AUTHOR'S REPLY

Revised schematic of "low-voltage drop-off" box.

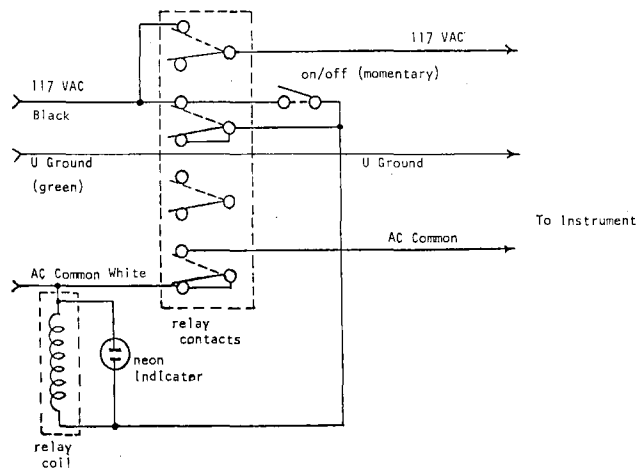
Dr. Richardson's comments concerning the permanent and continuous ground and the labeling of the "hot" lead are correct. This was a mistake on

my part while drawing and labeling the schematic. The figure above is a schematic with the appropriate corrections illustrating the proper design on our "low-voltage drop-off box".
